**Planning Department  
Transportation Development Services**

**Re: State of New Mexico Environment Department-Springer Building  
121 Tijeras Ave. NE  
Traffic Circulation Layout  
Engineer's/Architect's Stamp dated 4-20-15 (K14-D036)**

Based upon the information provided in your submittal received 5-12-15, the above referenced plan cannot be approved for Building Permit until the following comments are addressed:

1 SITE PLAN  
1" = 20'-0"

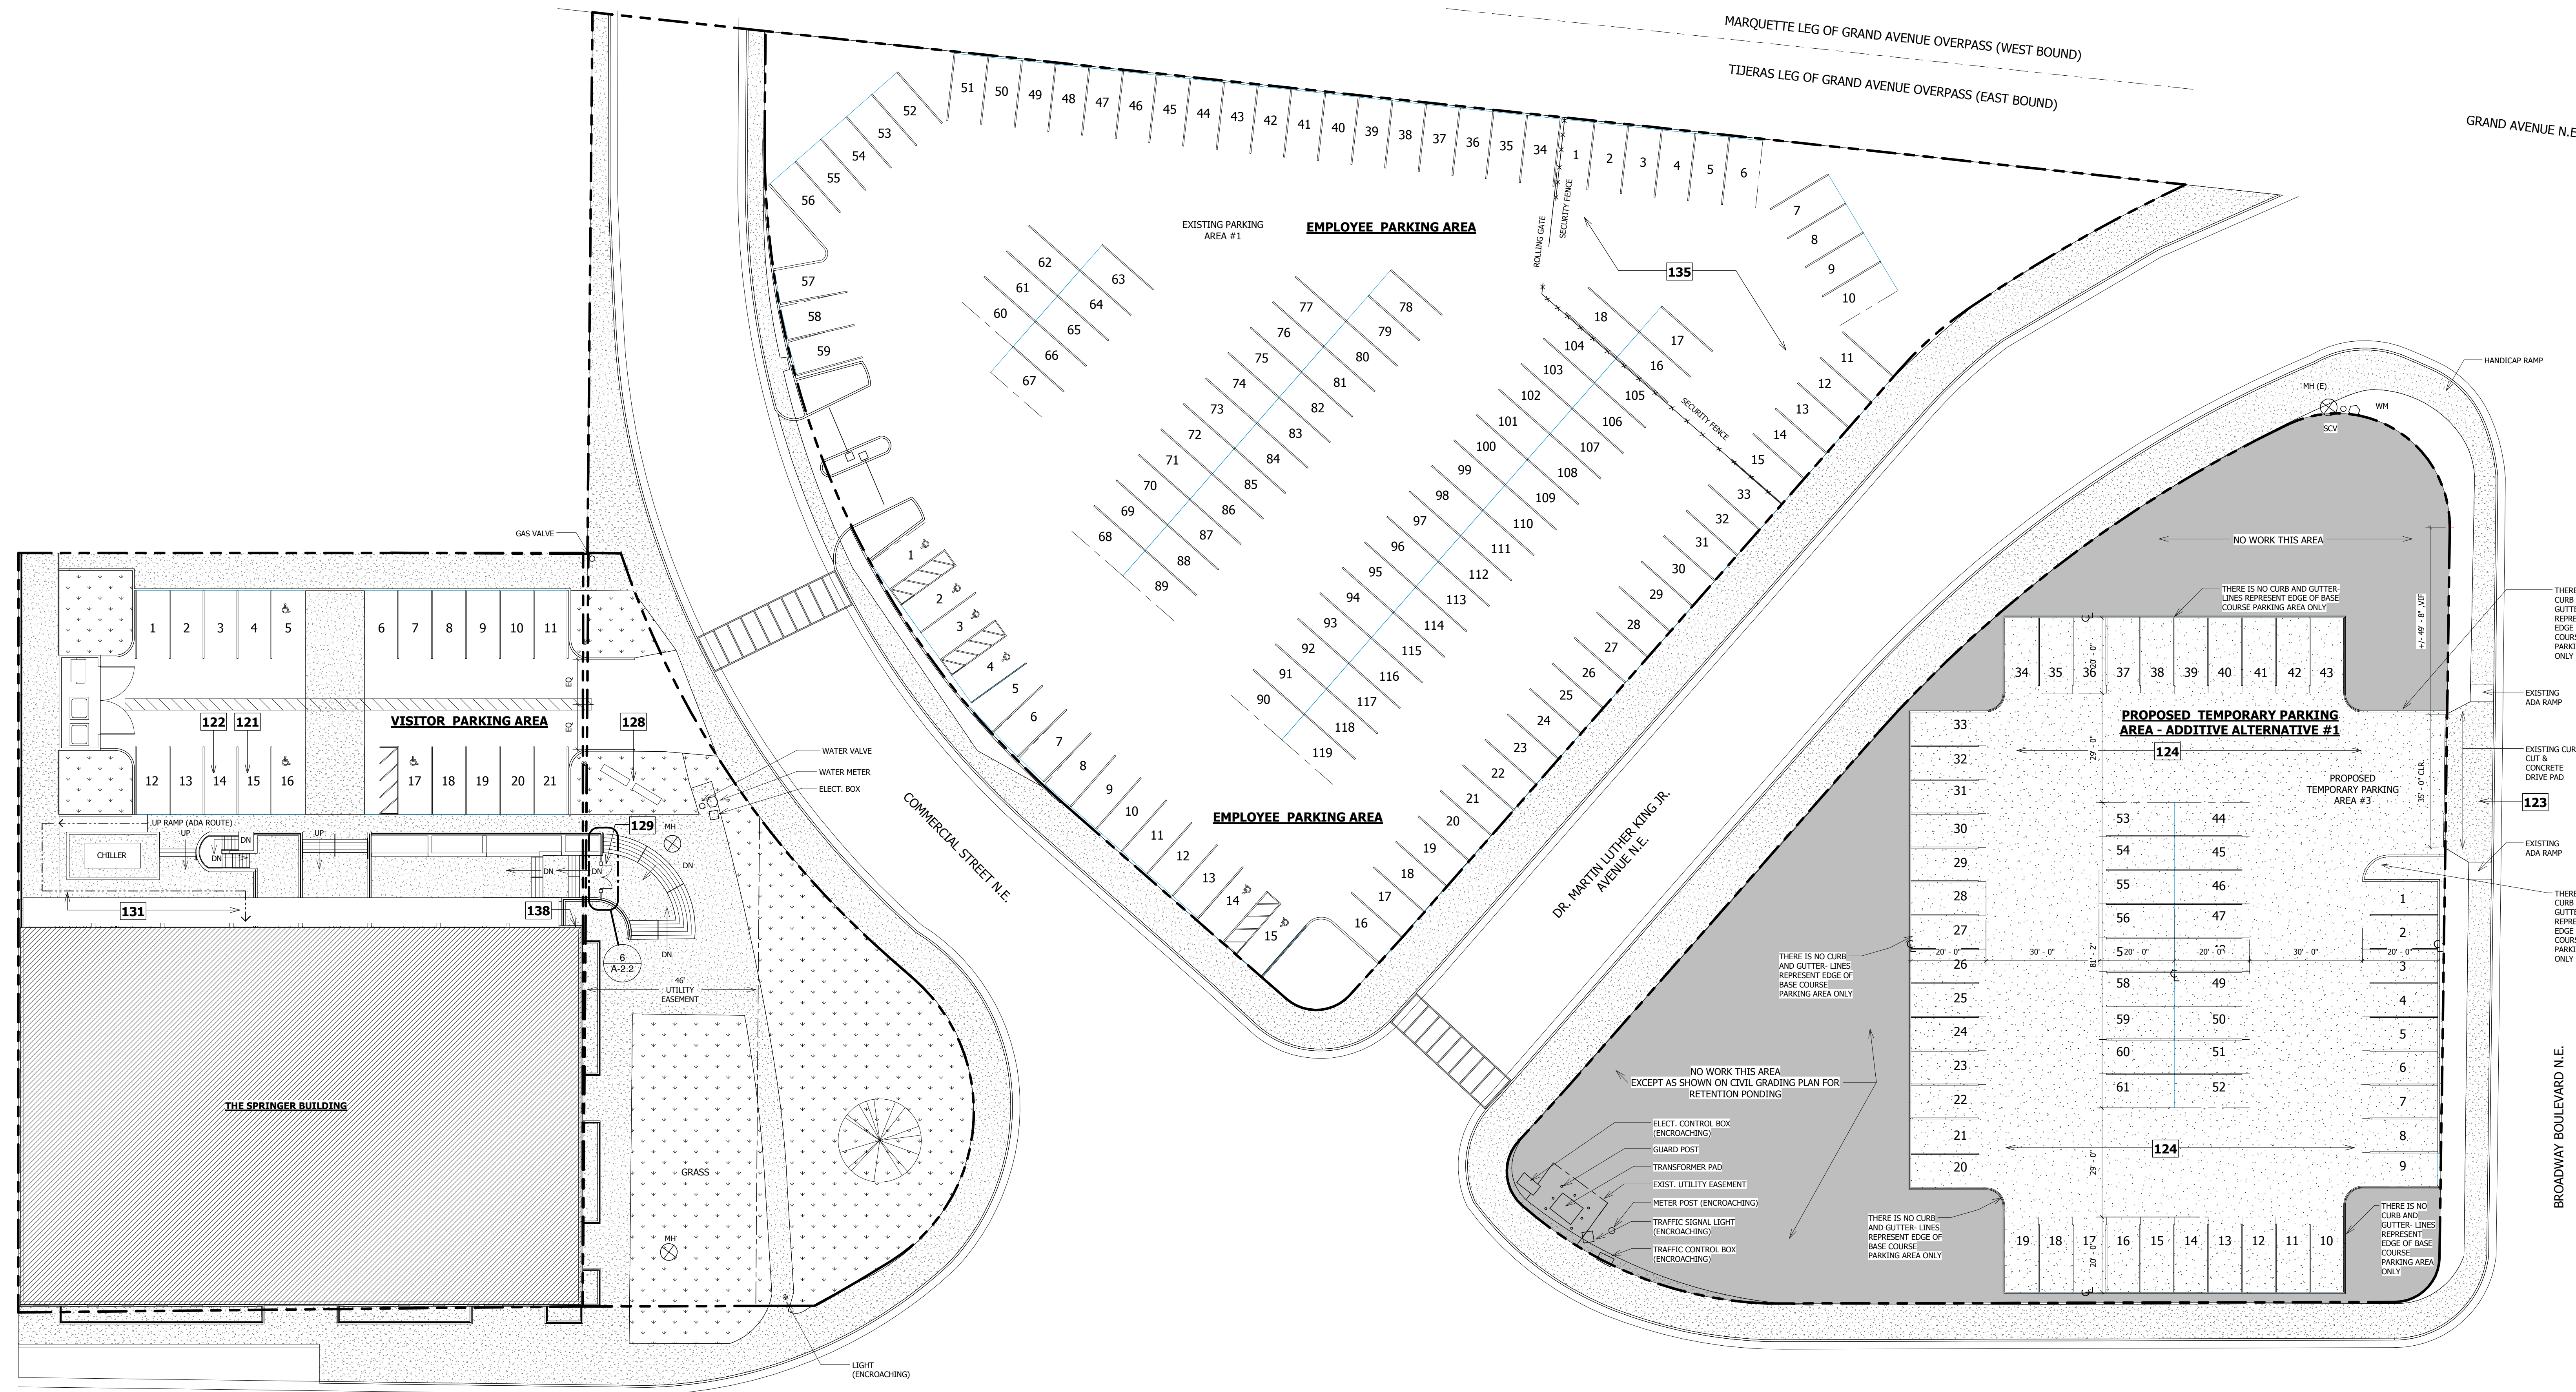
1. Please show a vicinity map showing the location of the development in relation to streets and well known landmarks.
2. Label new lot as "Overflow Parking".

3. Clarify the extents of the current phase. Please label existing buildings.
4. Please clarify the use of temporary parking. Is it be used just during construction?

5. Please identify all existing buildings, doors, structures, sidewalks, curbs, drive pads, walls and anything that influences the parking and circulation on the site.

6. Identify all existing access easements and rights of way with dimensions.
7. Identify the right of way width, medians, curb cuts, and street widths on Tijeras Ave., Dr. Martin Luther King Jr.Ave., and Commercial St.

8. The lot must be graded and surfaced with blacktop or equal: Two inches of asphalt concrete on a prime coat over a four inch compacted subgrade, or a surface of equal or superior performance characteristics. If street curbs and gutters exist adjacent to the parking lot property on a side where lot egress is allowed, the surfacing shall be blacktop for the width of the egress drive(s) and shall extend inward from the property line a minimum of 25 feet along all normal lines of egress traffic flow from the lot. All paving shall be maintained level and serviceable (i.e. no potholes). The City Engineer will have to approve a grading and drainage plan before the asphalt can be installed.

9. For parking lots of 20 or fewer spaces: A layer at least two inches thick of gravel sized from 3/8 minimum to one inch maximum diameter, at least ½ inch of which shall be maintained on the surface; gravel shall be kept off the right-of-way.

10. A parking lot shall include landscaping planted and maintained according to a Landscaping Plan approved by the Planning Director; however, the Planning Commission may waive this requirement where it is found not useful to achieving the intent of this Zoning Code.

11. The lot shall have barriers which prevent vehicles from extending over the sidewalk or abutting lots, or beyond the sides of a parking structure. The plans do already address providing concrete vehicular wheel stops.

12. Please list the width and length for all existing and proposed parking spaces. Please clearly detail how each parking space is to be marked and if there will be curb stop or car parking bumpers installed in each parking space. The minimum parking space width is 8.5 ft.

13. The ADA van accessible sign must have the required language per 66-7-352.4C NMSA 1978 **"Violators Are Subject to a Fine and/or Towing."** Please show a detail of the existing ADA signs.

14. The ADA access aisle shall have the words **"NO PARKING"** in capital letters, each of which shall be at least one foot high and at least two inches wide, placed at the rear of the parking space so as to be close to where an adjacent vehicle's rear tire would be placed. (66-1-4.1.B NMSA 1978)

15. Show all drive aisle widths and radii.
16. List radii for all curves shown; for passenger vehicles, the minimum end island radius is 15 feet. Landscape island radius for delivery trucks, fire trucks, etc. is 25 feet or larger

17. Per the DPM, a 6 ft. wide ADA accessible pedestrian pathway is required from the public sidewalk to the building entrances. Please clearly show this pathway and provide details from the proposed temporary parking.

18. Per the DPM, a 6 ft. wide ADA accessible pedestrian pathway is required from the HC parking stall access aisles to the building entrances. Please clearly show the ADA pedestrian pathway from the existing and proposed parking to the building entrance.

19. Provide a min 6" or max 8" high concrete barrier curb or other acceptable barrier between landscaping and parking areas and/or drive aisles.
20. Please provide a sight distance exhibit for entrance off of Broadway Blvd. (see the *Development Process Manual, Chapter 23, Section 3, Part D.5 Intersection Sight Distance*).

21. Please add the following note to the clear sight triangle: "Landscaping and signage will not interfere with clear sight requirements. Therefore, signs, walls, trees, and shrubbery between 3 and 8 feet tall (as measured from the gutter pan) will not be acceptable in this area."
22. Please specify the City Standard Drawing Number when applicable.
23. Work within the public right of way requires a work order with DRC approved plans.
24. See Chapter 23, Section 6 of the City of Albuquerque *Development Process Manual*, for appropriate drive pad widths.
25. Please include two copies of the traffic circulation layout at the next submittal.
